No: 26-085

DAUPHIN COUNTY SUBDIVISION/LAND DEVELOPMENT REVIEW REPORT

Plat Title: Vincent J. Fumo & Debbie Pastrana

Project Description: Proposed Subdivision for side yard addition.

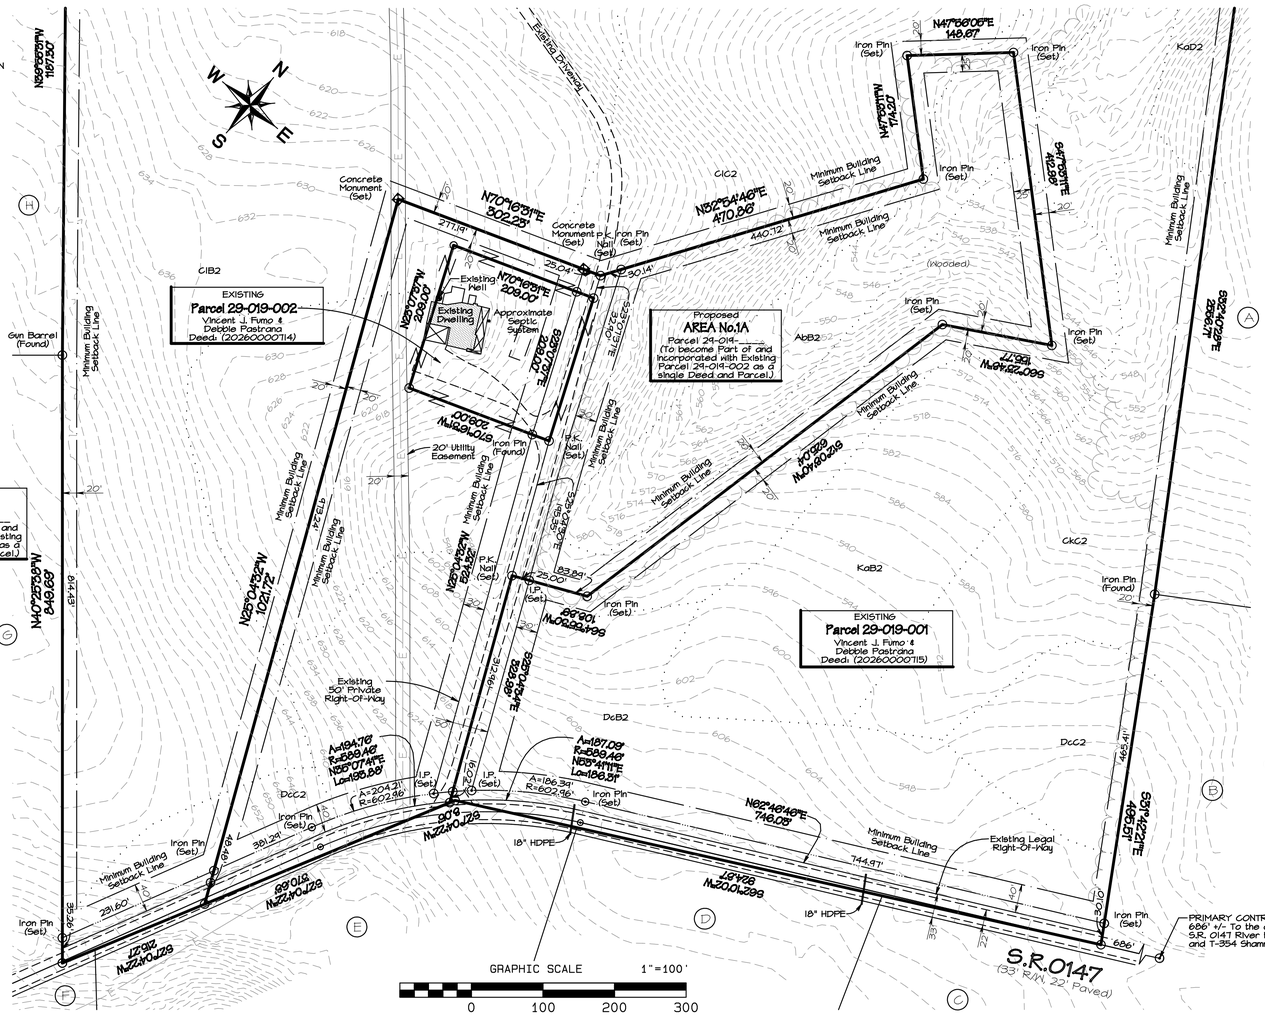
1. The plan shall be drawn at a scale not less that 1"=50'. (S-LD § 405.1.a per 407.1.a) The application displays the applicants intent to request a modification of this requirement.
2. The location map is required to be drawn at a scale not less than 1"=1,000' (S-LD § 405.1.a.iv per 407.1.a)
3. All signatures, seals, and notarizations must be acquired upon final plan approval. (S-LD § 407.1.a.xi)
4. Curbs on the site may be required in accordance with Section 606 of the Halifax Township SALDO. The plan displays the applicants intent to request a modification of this requirement.
5. Sidewalks on the site may be required in accordance with Section 607 of the Halifax Township SALDO. The plan displays the applicants intent to request a modification of this requirement.
6. Monuments and markers shall be set in accordance with S-LD § 602.
